RENESAS TECHNICAL UPDATE

Product Category	MPU/MCU		Document No.	TN-RX*-A0231A/E	Rev.	1.00
Title	Errata to User's Manual: Hardware Regarding the I ² C-bus Interface (RIIC)		Information Category	Technical Notification		
Applicable Product	RX210 Group, RX220 Group, RX62G Group, RX62T Group	Lot No.	Reference Document	RX210 Group User's Manual: Hardware Rev.1.50 (R01UH0037EJ0150) RX220 Group User's Manual: Hardware Rev.1.10 (R01UH0292EJ0110) RX62T Group, RX62G Group User's Manual: Hardware Rev.2.00 (R01UH0034EJ0200)		
		All

This document describes corrections to the "I²C Bus Interface (RIIC)" chapter in User's Manual: Hardware for the applicable products.

Figure 30.28 Set/Clear Timing of the AASy and DID Flags during Reception of Device-ID Address

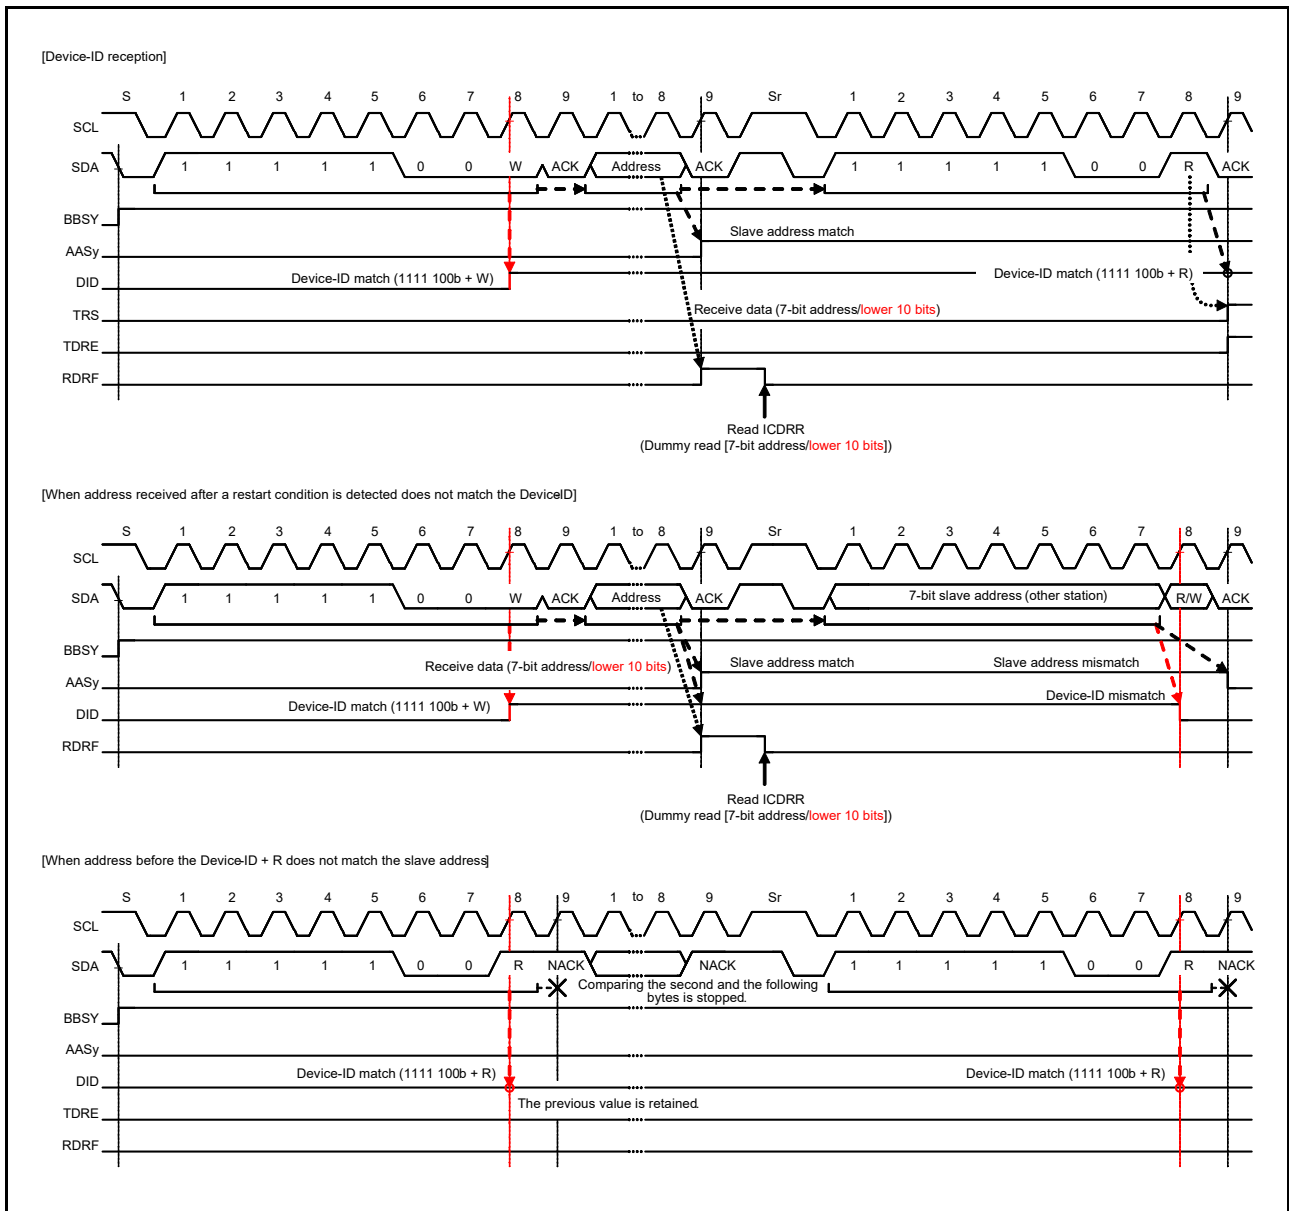
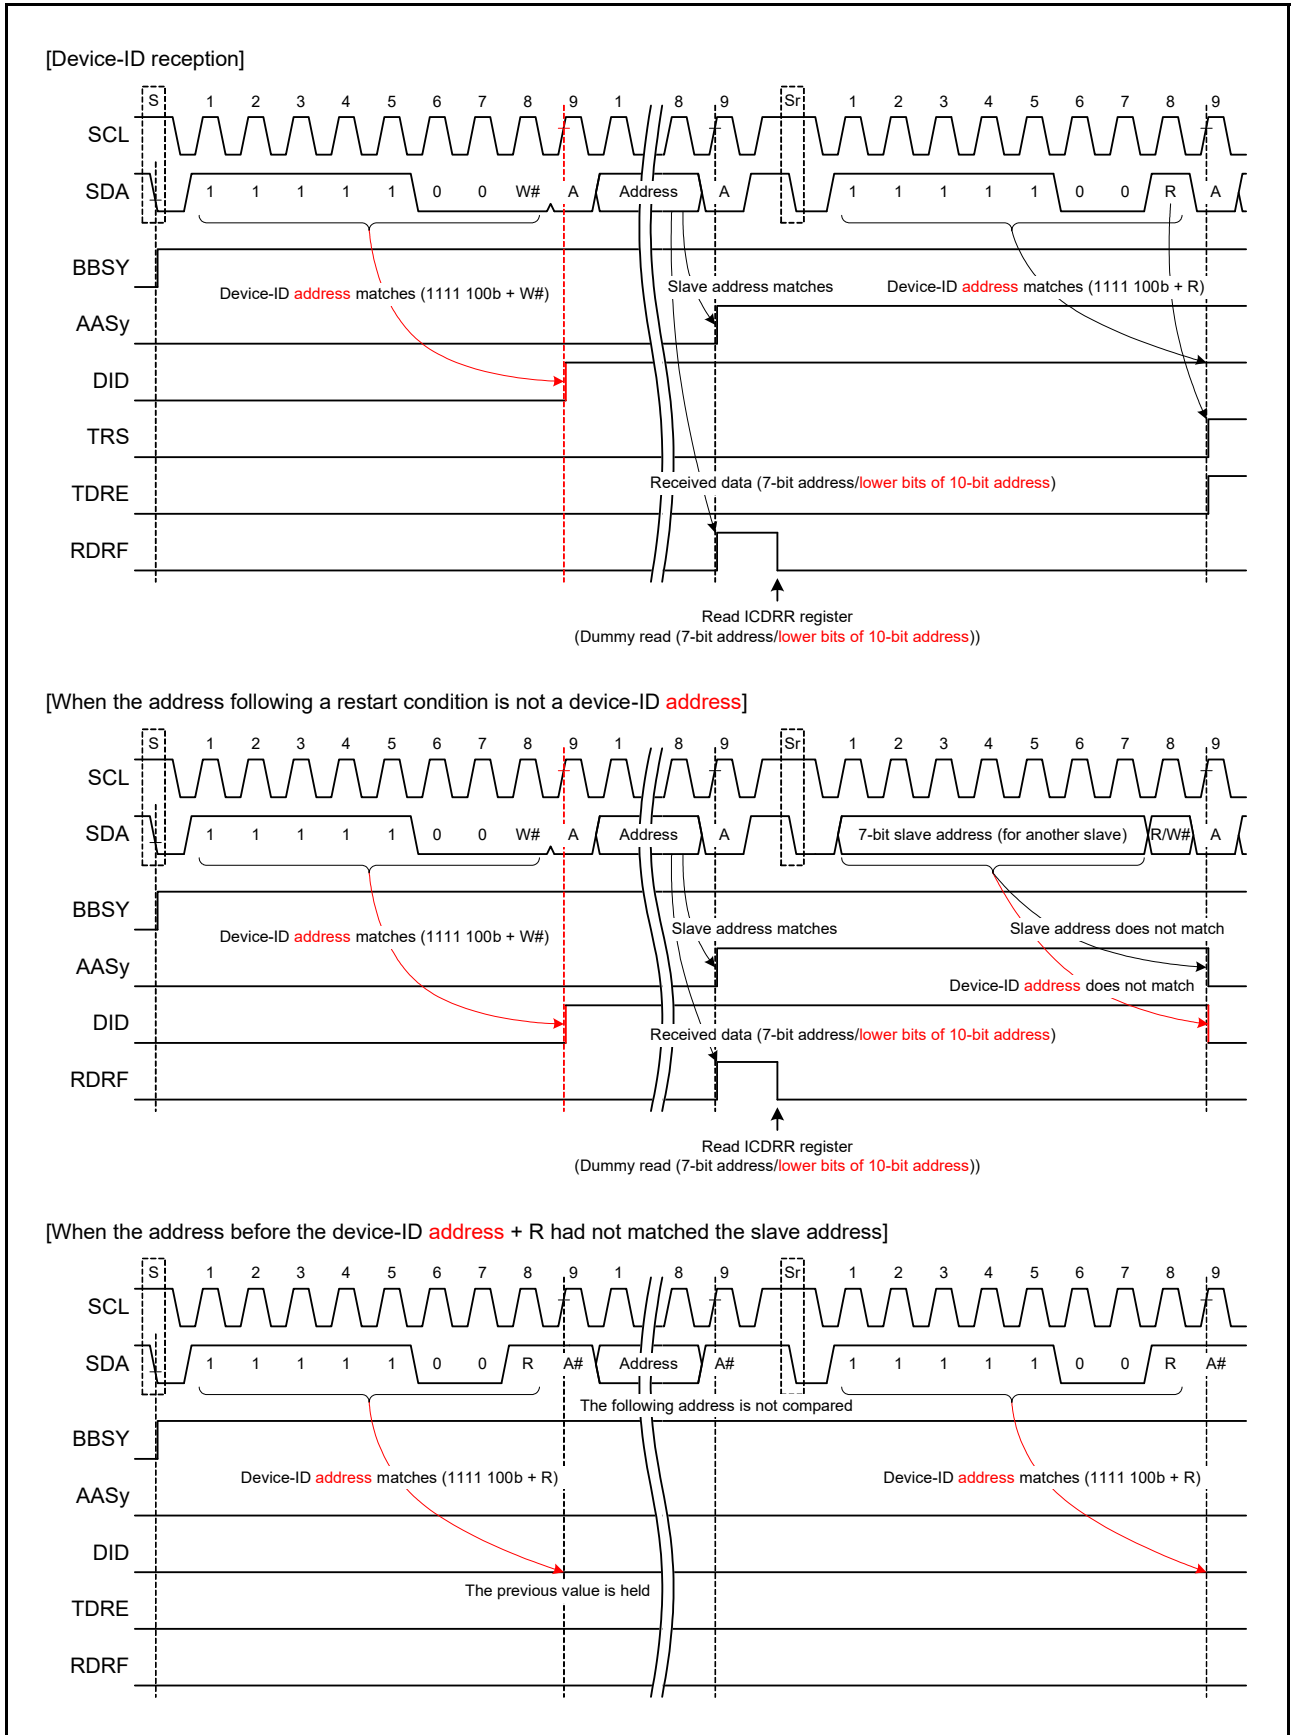
Figure 30.28 in section 30.7.3, Device-ID Address Detection is corrected as follows.

Figure 30.31 Suspension of Data Transmission When NACK is Received (NACKF = 1)

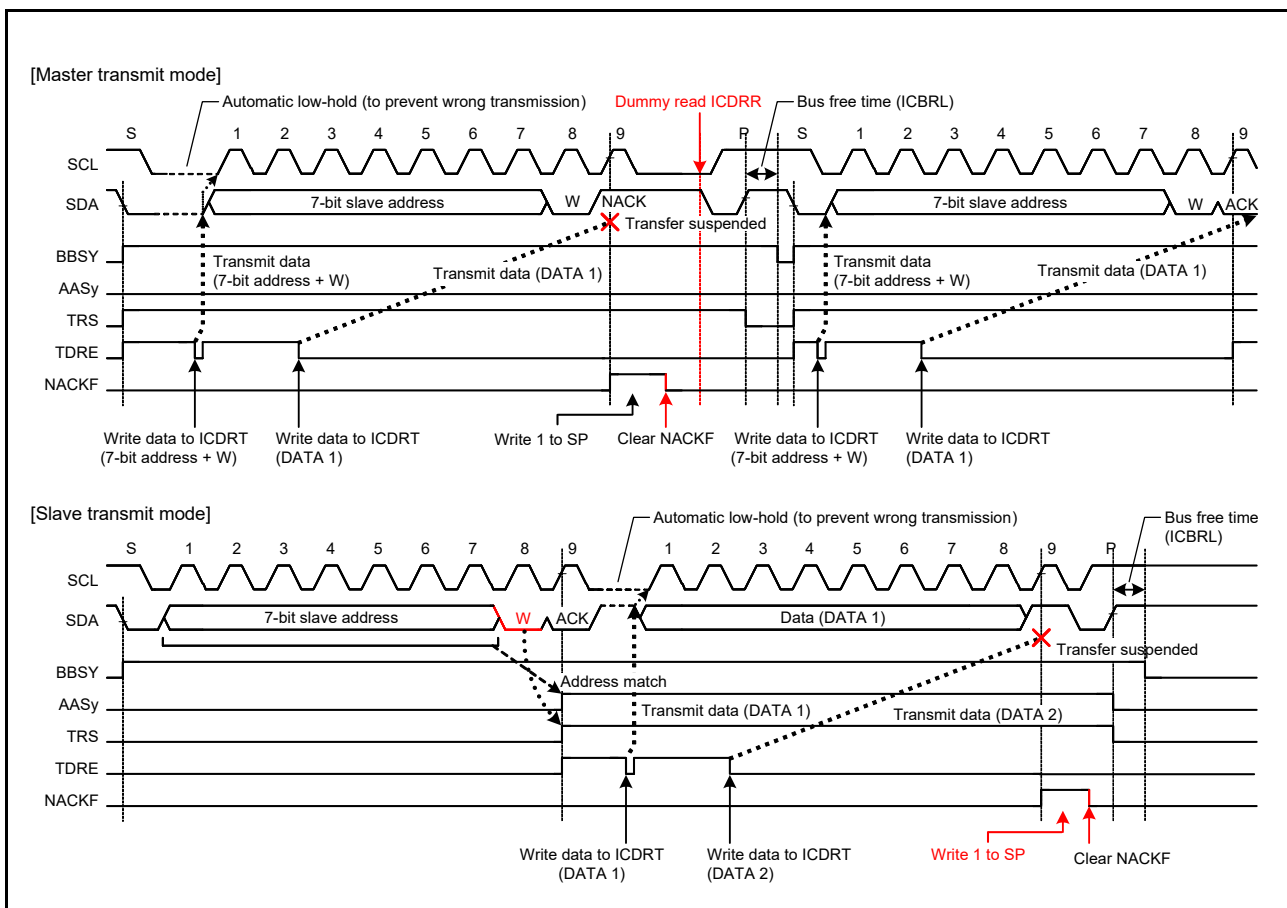
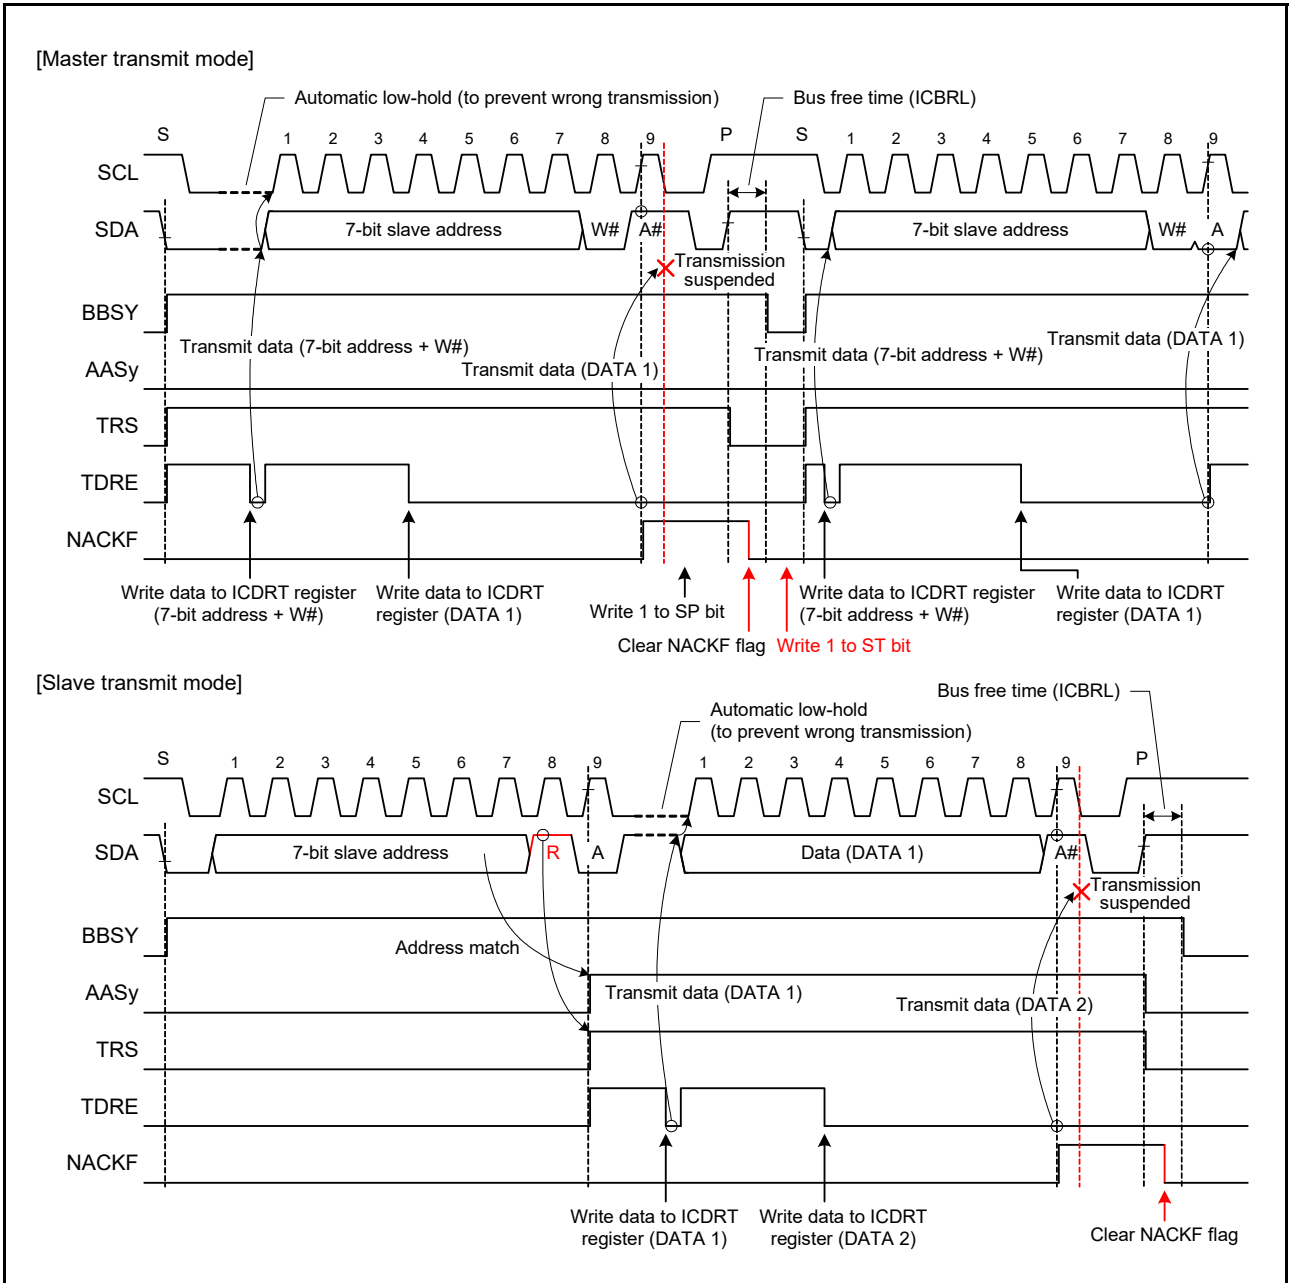
Figure 30.31 in section 30.8.2, NACK Reception Transfer Suspension Function is corrected as follows.

Figure 30.40 Additional SCL Output Function (CLO Bit)

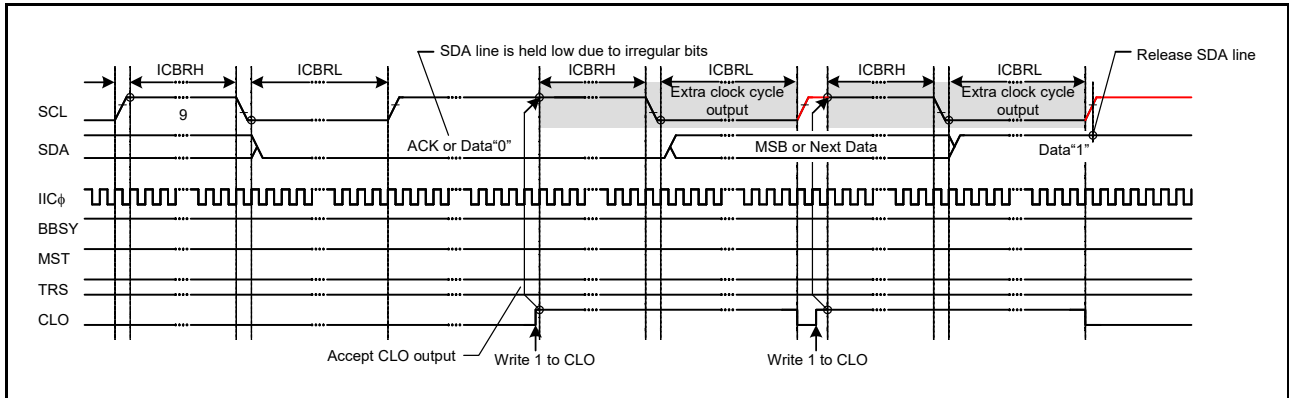
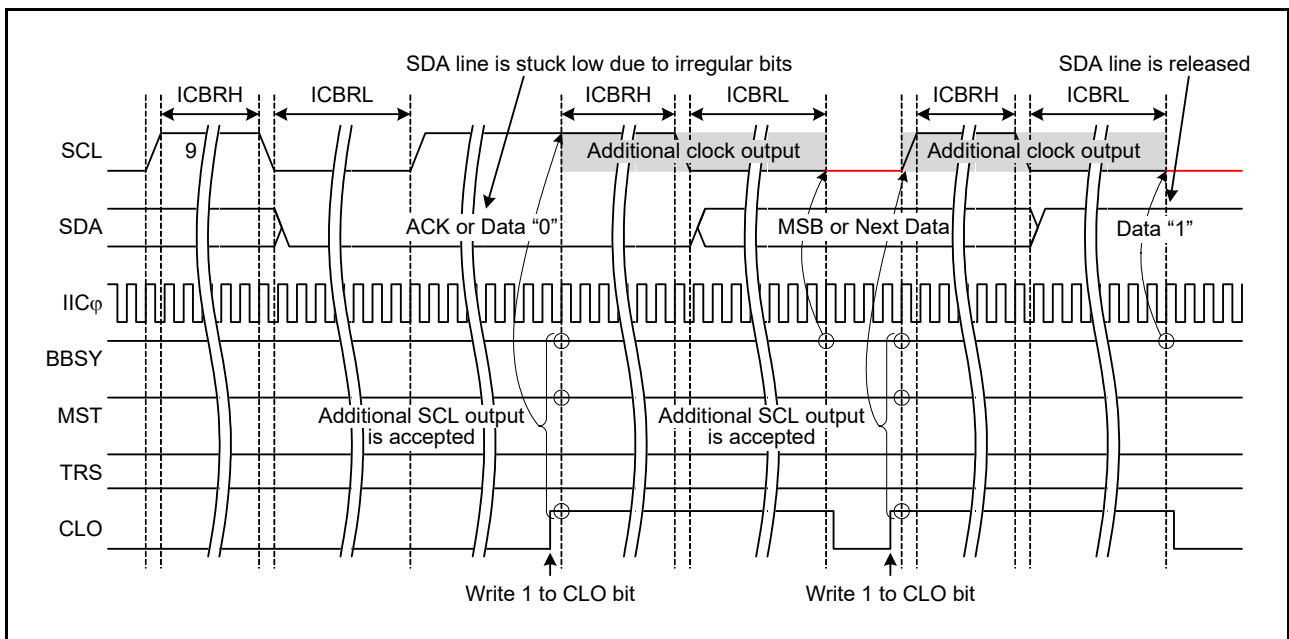
Figure 30.40 in section 30.11.2, Extra SCL Clock Cycle Output Function is corrected as follows.
